ITEM NO: 9

SUBJECT: DEVELOPMENT APPLICATION NO. S/15/2005 FOR A TWO LOT INTO FORTY TWO LOT SUBDIVISION ON LOT 400 DP 591224, NO. 292 GREAT WESTERN HIGHWAY, WARRIMOO AND LOT 401 DP 591224, 25 THE MALL, WARRIMOO.

FILE NO: S/15/2005

Attachment 1 – Amended Plan for a 2 into 42 Lot Subdivision

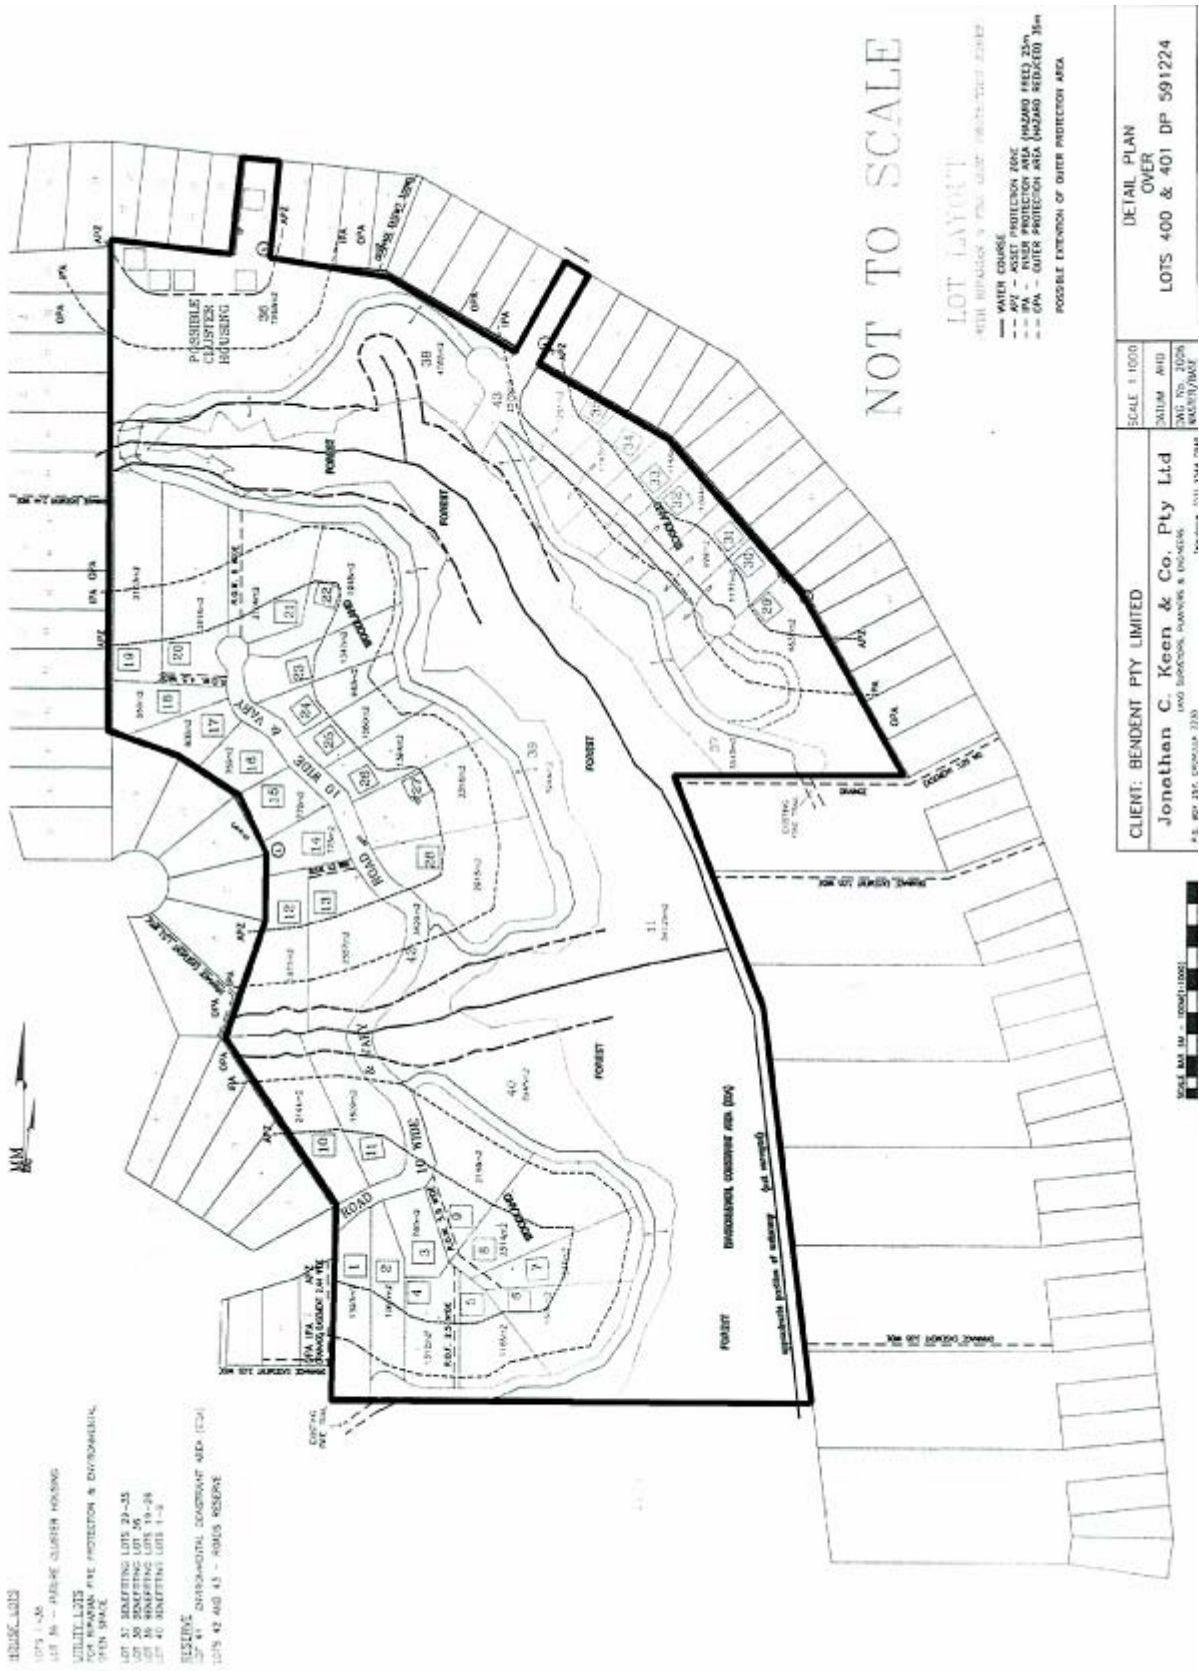
1. *The proposed subdivision does not comply with the following provisions of the Blue Mountains LEP 1991, in that:*
 - a) *The proposed lot yield exceeds the maximum yield calculated in accordance with the LEP 1991 (Clauses 34.1(b) & 34.4((b));*
 - b) *All proposed lots (other than lots for a public purpose) created in the Residential Bushland Conservation zone do not include a minimum of 750m² of land which is not Development Excluded Land, and which is suitably configured to be capable of being the site of a dwelling house and accommodating development ordinarily incidental and ancillary to a dwelling house (Clause 34.1(c));*
 - c) *The proposed subdivision achieves a lot density in excess of the Density Control Provision (Clause 34.4(a)).*

2. *The proposed subdivision does not comply with the following objectives of the Residential Bushland Conservation zone of the Blue Mountains LEP 1991, in that it does not:*
 - a) *Ensure that the development is environmentally sensitive and site responsive and maintains and facilitates sustainable natural ecosystems and biodiversity within the Blue Mountains (Clause 6.3(a));*
 - b) *Utilise best practise water management techniques to protect and improve existing non-perennial watercourses and the associated riparian zones, to protect and improve water quality, and to maintain pre-development downstream flow patterns (Clause 6.3(b));*
 - c) *Ensure that the proposed bushfire protection measures are able to be implemented without unacceptable adverse environmental impact (Clause 6.3(e)).*

- a) *Protect environmentally sensitive land (Clause 7.2(a));*
 - b) *Provide a buffer around areas of ecological significance (Clause 7.2(b));*
 - c) *Restrict development on land that is inappropriate by reason of its physical characteristics and its bushfire risk (clause 7.2(c)).*

5. *The proposed subdivision results in adverse environmental impact, in that it:*
- a) *Does not incorporate measures specified in accordance with any Development Control Plan that shows requirements for erosion and sedimentation control (Clause 105(a)(i));*

- b) *Does not incorporate best management practice water management techniques to protect the surface and ground water regimes and water quality for the site (clause 10.5(a)(iv));*

- c) *Does not ensure that the bushfire protection measures required to protect the land to be subdivided do not have any adverse environmental impact on any development excluded land (Clause 10.5(c));*

- d) *Does not incorporate effective measures, satisfactory to the Council, to ensure that the development has no adverse environmental impact on any development excluded land (Clause 10.5(db));*

6. *The proposed subdivision does not comply with the relevant provisions of the Council's Better Living DCP, in particular:*
- a) *E3.1 Matrix of Plans and Documentation – the application does not include a dimensioned proposed plan of subdivision, a detailed environmental assessment of the impacts of the proposal, a vegetation/bushland management plan, a geotechnical report, an erosion and sediment control plan, or a new archaeological site survey;*

- b) *E3.2 Biodiversity – the proposal does not minimise the number of lots that contain Development Excluded Land;*
 - c) *E3.4 Stormwater – the proposal does not demonstrate how the stormwater system shall achieve post construction water quality objectives listed in the Better Living DCP;*

- d) *E3.5 Streetscape and Character – Not all proposed lots are able to provide a Development Space that does not include any Development Excluded Land*

- e) *E3.7 Bushfire – the proposal includes bushfire protection measures that intrude into Development Excluded Land and buffers to the watercourse;*
 - f) *E3.10 Wastewater – the proposal does not demonstrate that the development space on each lot is capable of being drained by a gravity sewer connection without any constraint on the floor level;*

- g) *E3.11 Vehicular Access, parking & Roads – the proposed road reserves are under width;*
 - h) *E3.12 Accessibility – The application does not address the requirement for pedestrian pathways in accordance with AS1428 – Design for Access & Mobility*
7. *The proposed subdivision is considered to be an overdevelopment of the site.*
 8. *The proposed subdivision is contrary to the General Terms of Approval issued by the Department of Infrastructure Planning and Natural Resources, in that the bushfire protection measures extend into the riparian zones*
 9. *The SEPP1 Objection is not well founded in that it has not demonstrated that strict compliance with the standards is unreasonable and unnecessary.*

The site contains mapped ECA, as well as other areas steeper than 33% (and therefore deemed to be ECA by cl 10.5(e)). ECA within the site is adversely affected by the impacts of road, drainage, fire trail and services construction, impacts of hazard reduction to achieve APZs, and impacts of stormwater drainage discharge.	
General Control of Development			
cl 9.1	Permissibility within the RBC zone	Subdivision is permissible within the RBC zone with Council consent	Yes, with Council's consent
cl 9.3	Compliance with the relevant objectives of the plan, zone and protected area	As described above, it is considered that the proposal does not comply with all of the relevant objectives of the plan, zone and protected area. cl 9.3. On this basis, the Council shall not grant consent to this development.	No
Development Criteria - General			
cl 10.2	Access	Part (b) of this clause states: <i>'The Council shall not consent to development which requires an on-site access road unless such road is designed and constructed to minimise grades, to suit contours, and to be stable, taking into account the characteristics of the site and the locality and should avoid slopes of 33% or greater.'</i> The proposal includes onsite access roads. A longitudinal section of the proposed road alignments were submitted with the original application. Given the route of the proposed roads, and the topography of the site, the submitted longitudinal section minimises the grades of the proposed roads. However, the grade of the proposed roads are up to 18.5%, which exceeds the desirable (12%) and absolute maximum (16%) grades permitted in Council's DCP31. Relatively minor changes to the design could achieve compliance with the absolute maximum gradient. Compliance with the desirable maximum grades would require significant changes to the design in both the	No

<p>horizontal and vertical alignments. These changes to the horizontal and vertical alignments are likely to require a total redesign the subdivision layout.</p> <p>The route of the proposed roads varies between parallel, diagonal and perpendicular to the contours. The longitudinal gradient of the road could be reduced by realigning the road more parallel to the contours, however this is likely to significantly increase the length of the road (and hence site resultant disturbance) to provide access to all of the proposed lots.</p> <p>Should the application be approved, the roads would be conditioned to be constructed in asphalt or concrete, and as such would be stable.</p> <p>The proposed road alignment affects land steeper than 33% (based upon the applicant’s contours) adjacent to proposed lots 13 and 28. It is unlikely that an access could be redesigned to totally avoid land steeper than 33% without wholly redesigning the subdivision layout.</p> <p>A possible solution to reduce the extent of the road construction could be to focus development into precincts off The Mall, the Great Western Highway and (subject to land ownership) off Arthur Street.</p>

cl E3.2	Biodiversity	<p>The DCP recommends that the subdivision be designed so as to minimise the number of lots that contain DEL. Based upon land steeper than 20% alone, only two of the proposed lots do not contain DEL. As previously noted, if a competent flora and fauna study were to be submitted, it is likely to indicate additional lots as being impacted by DEL.</p>	No
cl E3.4	Stormwater	<p>The proposal provides no documentation to demonstrate that the stormwater system shall achieve post construction water quality objectives listed in the DCP.</p>	No
cl E3.5	Streetscape & Character	<p>The applicant claims that only Lot 28 cannot provide a 300m² Development Space (with dimensions 12 by 25m or 15 by 20m) that does not include any DEL.</p> <p>It is the Council Officers' assessment that a total of 9 proposed lots are not capable of accommodating the appropriately configured</p>	No

Development Space without intruding on DEL, and that a further 10 lots have questionable Development Spaces due to the need to access them through DEL and their location in respect to intrusion into front building setbacks and APZs.	
cl E3.7	Bushfire	<p>This DCP requires that any measures proposed to protect development against bushfire shall be undertaken on those parts of the site that are not DEL, and that APZs are not to intrude into the buffer to a watercourse.</p> <p>Further, the DCP requires that perimeter roads must be 7m wide kerb to kerb. The proposal includes a perimeter road 6m wide kerb to kerb.</p> <p>The BFSAs issued by the RFS requires that the roads comply with Section 4.3.1 of Planning for Bushfire Protection 2001. This document requires 8m wide carriageways for roads in bushfire prone areas.</p> <p>Roads of this width would clearly exacerbate the adverse impacts on the DEL already generated by the design as submitted.</p>	No

<p>The proposed road reserve widths are generally 11 and 13m wide.</p> <p>This DCP requires that the road reserve widths for public access and roads is to be at least 15m wide unless the road is a shareway, in which case a minimum reserve width shall be 12m.</p> <p>The DCP limits the number of dwellings or lots to be accessed from a shareway to a maximum of 4. Both proposed roads provide access to more than 4 allotments. Accordingly the proposed roads should be contained within reserves of at least 15m in width.</p> <p>Further, as Road No.1 accesses more than 20 lots, this DCP requires that a 1.2m wide concrete footpath be constructed along one side of the new road.</p>	
cl E3.12	Accessibility	<p>The DCP requires that where more than five allotments are created with a full street frontage, pedestrian pathways shall meet the requirements of AS1428 – Design for Access & Mobility.</p> <p>The application does not address this matter, and does not demonstrate that pedestrian pathways meet the requirements of AS1428.</p>	No

The application acknowledges that proposed Lot 28 does not comply with this requirement, and seeks an exemption for Lot 28 under SEPP1.

The applicant claims that Lot 28 contains at least 750m2 of developable land, but this land is unsuitable to locate a dwelling as it is too close to the cliff-top and ECA, and falls wholly within the proposed APZs. The applicant suggests that Lot 28 contains a suitable building area on partly disturbed land outside the APZ. The applicant notes that this area is ‘notionally within development excluded land’.

As it stands, proposed Lot 28 does not contain any land which is not DEL that is appropriately configured to be the site of a dwelling house and to accommodate development ordinarily incidental and ancillary to a dwelling house.

The proposed APZs and fire trails intrude onto DEL, being land steeper than 20% and within the riparian zones.

The 42 lot subdivision of the site still maintains APZs and fire trails within the riparian zones contrary to the terms of DIPNR's GTA.
